Docket Item # 5 & 6  
BAR CASE # 2014-00028  
2014-00029

**ISSUE:** Partial Demolition and Alterations

**LOCATION:** 1201 E Abingdon Drive

**BAR2014-00028 & BAR2014-00029**

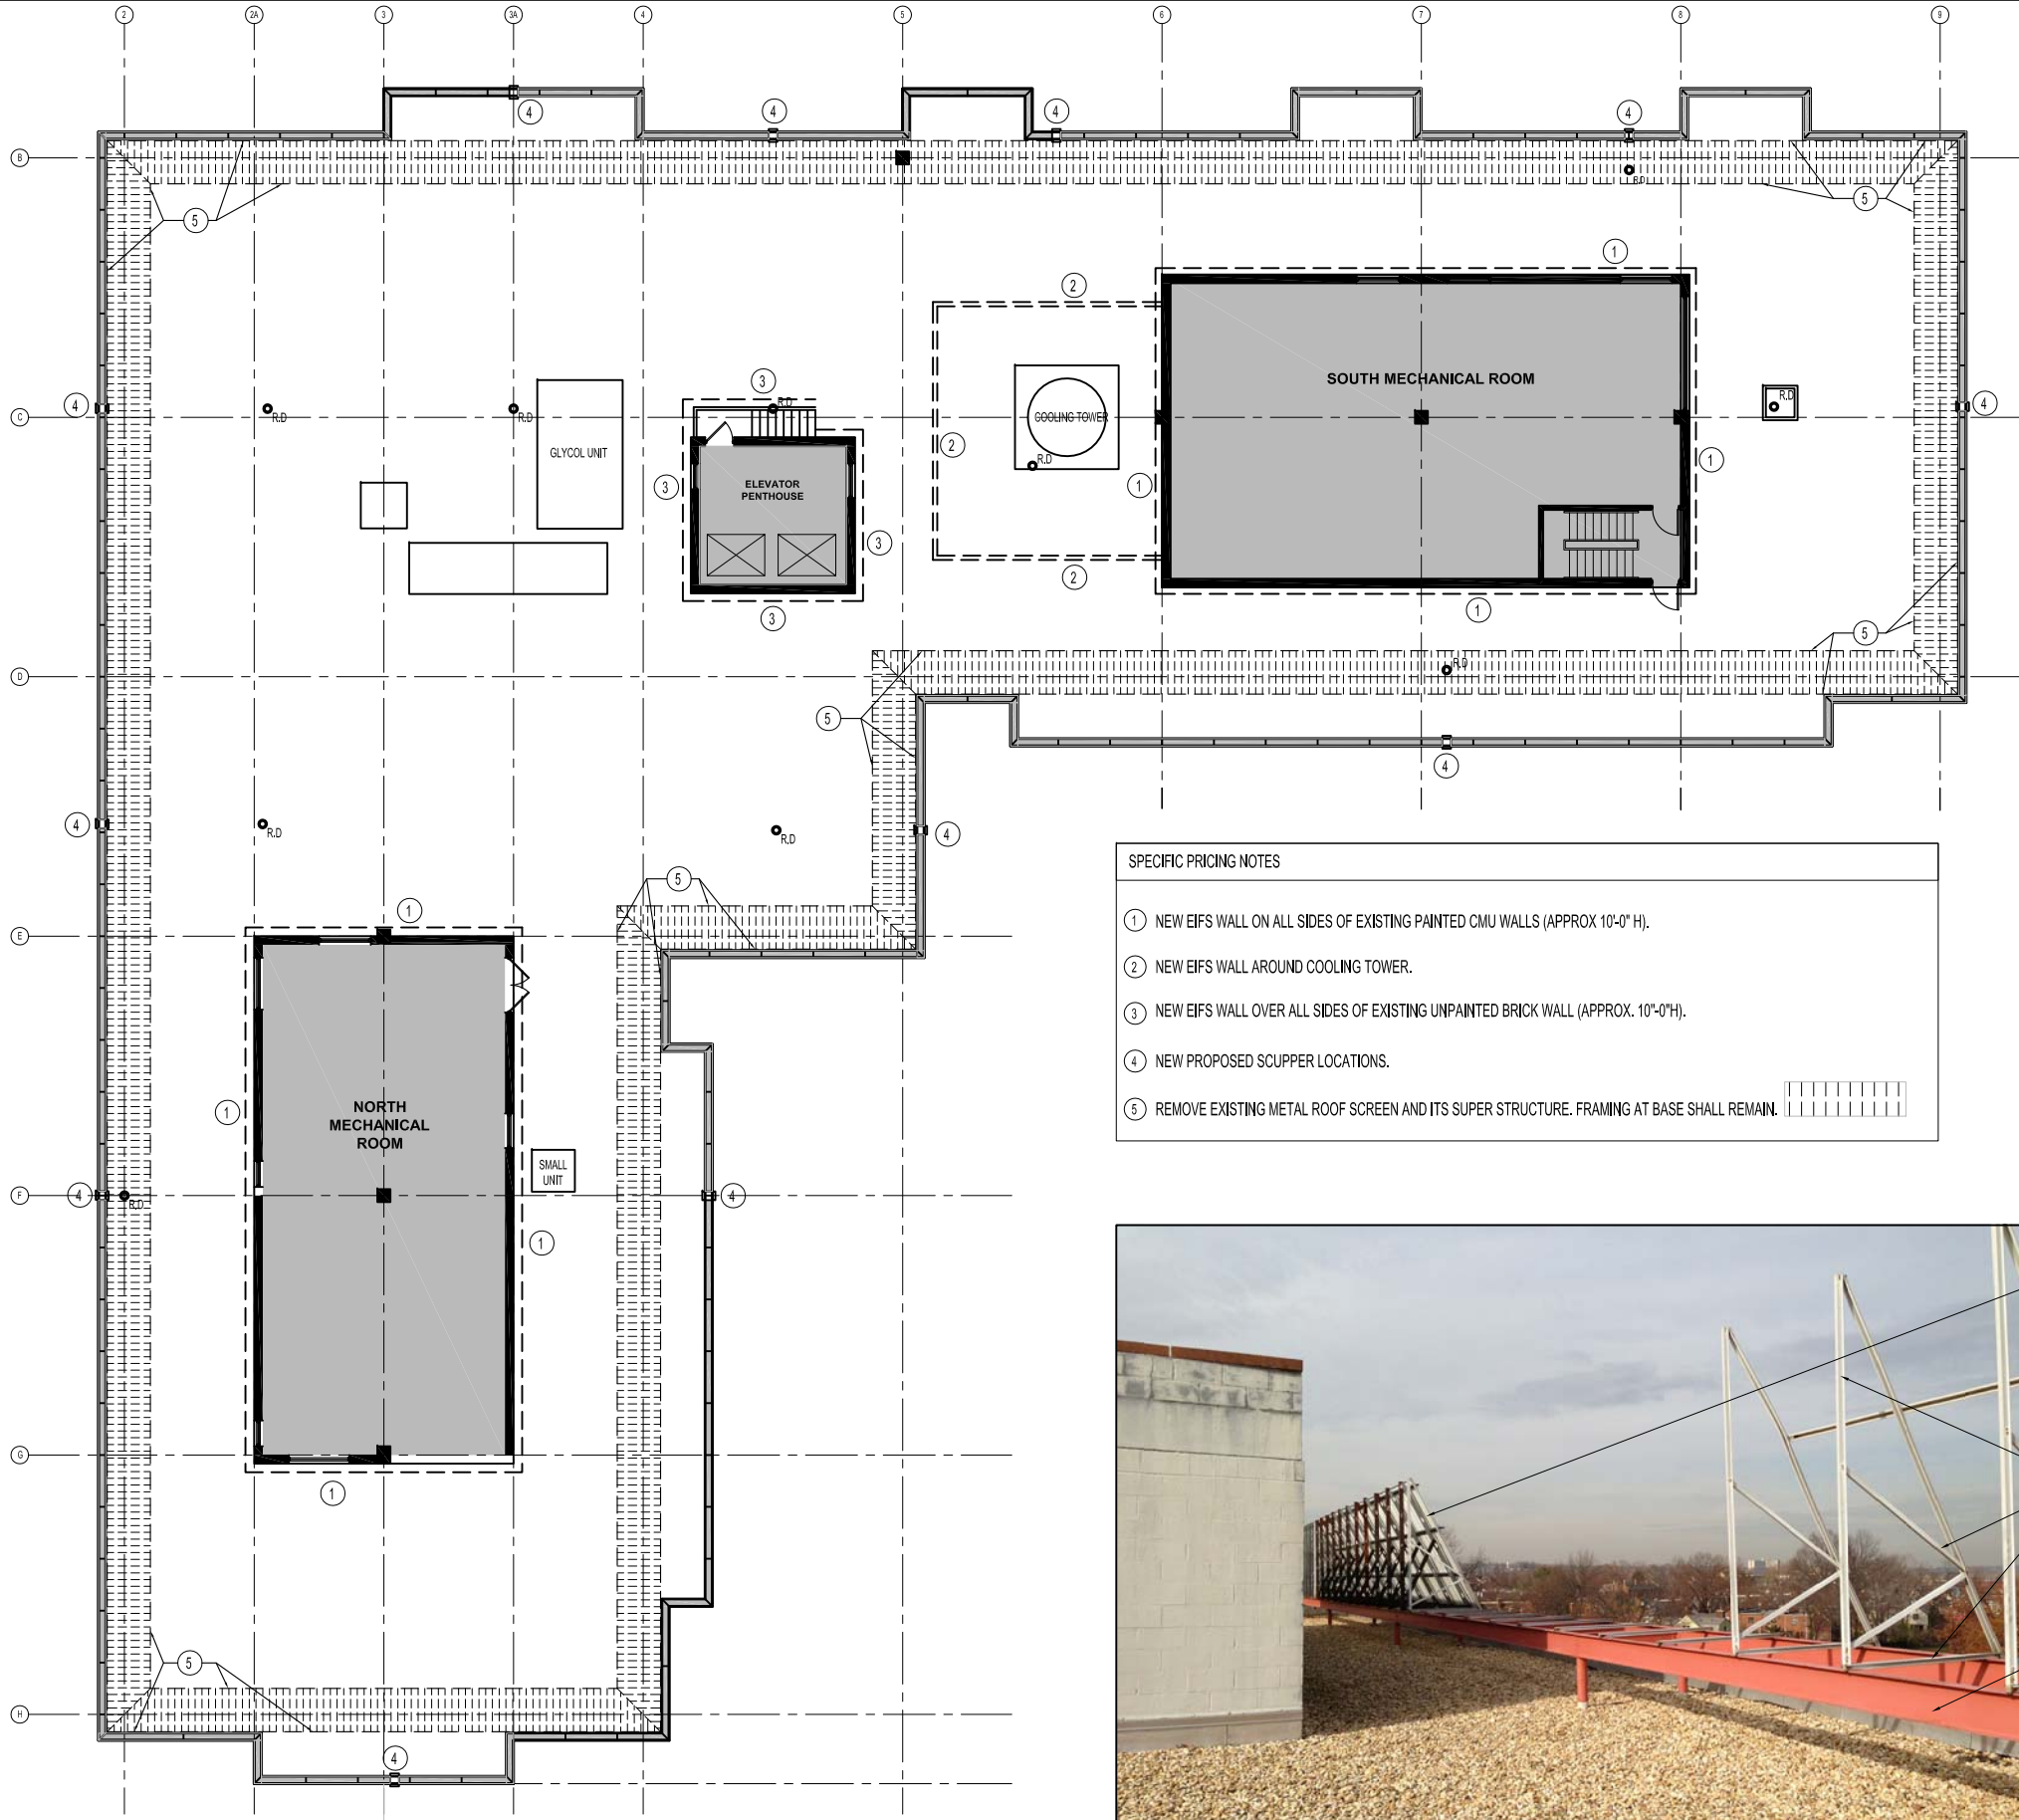
The applicant is requesting a Permit to Demolish an existing metal roof screen at 1201 East Abingdon Drive. The removal of the metal screening will leave exposed one brick clad elevator penthouse, two mechanical rooms clad with painted CMU (Concrete Masonry Units), and an exposed cooling tower. The applicant requests a Certificate of Appropriateness to install new EIFS (Exterior Insulation and Finish System is a synthetic stucco) around each of these items and place twelve new scuppers at locations indicated on the attached plans. The proposed changes will be visible from the George Washington Memorial Parkway.

Staff supports removal of the existing mansard screen because it will simplify the building and reduce its visible mass. While the existing mechanical penthouses are themselves undeniably large, the existing condition photographs seem to indicate that the building mass will still be substantially less if the screen is removed. Staff finds that none of the criteria from section 10-105(B) of the zoning ordinance are met and that a Permit to Demolish should be granted.

1. The elevator penthouse remain unpainted red brick that matches the building;
- 1.) The new EIFS may not exceed 15 feet in height from the top of the roof; and
- 2.) The new screening must be painted a light grey color with final approval of the color by staff.

Roof Top Level  
Sheet 1  
12/9/13  
Not to Scale

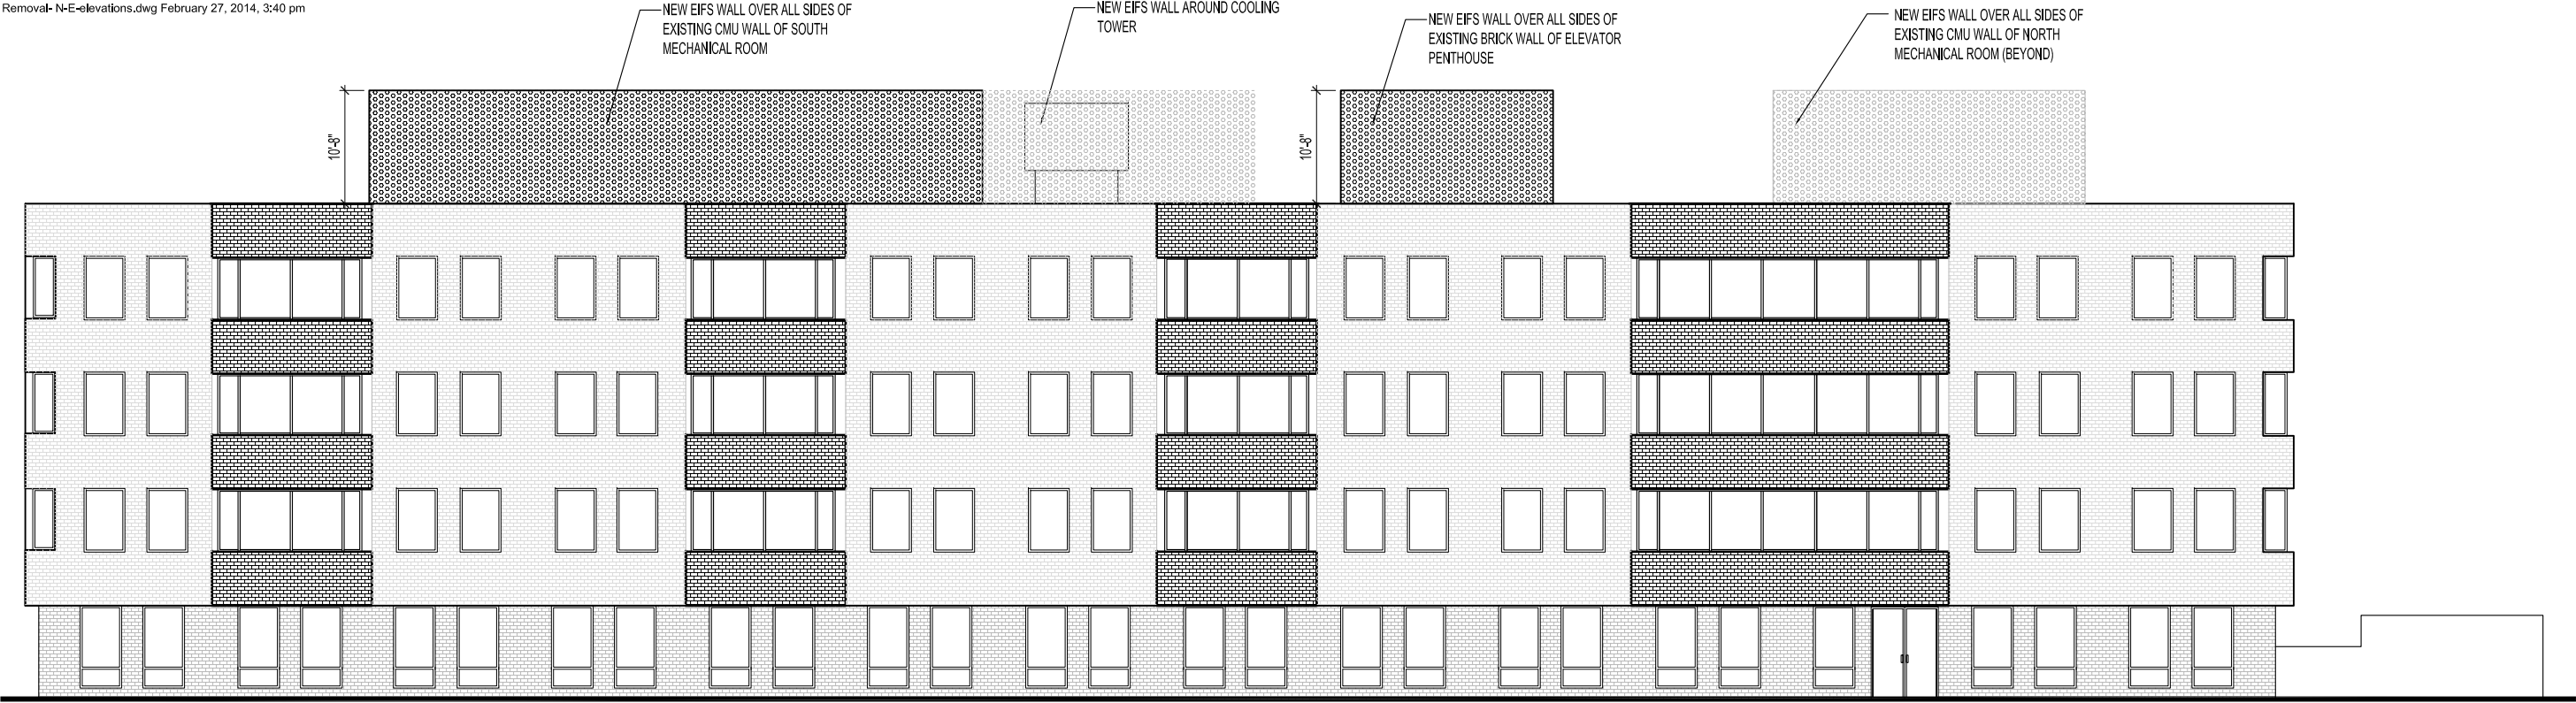
- SPECIFIC PRICING NOTES
- ① NEW EIFS WALL ON ALL SIDES OF EXISTING PAINTED CMU WALLS (APPROX 10'-0" H).
  - ② NEW EIFS WALL AROUND COOLING TOWER.
  - ③ NEW EIFS WALL OVER ALL SIDES OF EXISTING UNPAINTED BRICK WALL (APPROX. 10'-0"H).
  - ④ NEW PROPOSED SCUPPER LOCATIONS.
  - ⑤ REMOVE EXISTING METAL ROOF SCREEN AND ITS SUPER STRUCTURE. FRAMING AT BASE SHALL REMAIN.

DEMOLISH EXISTING METAL ROOF SCREENS

DEMOLISH EXISTING "SUPER STRUCTURE"

EXISTING SUPPORT STRUCTURE FOR METAL ROOF SCREEN TO REMAIN AS IS.
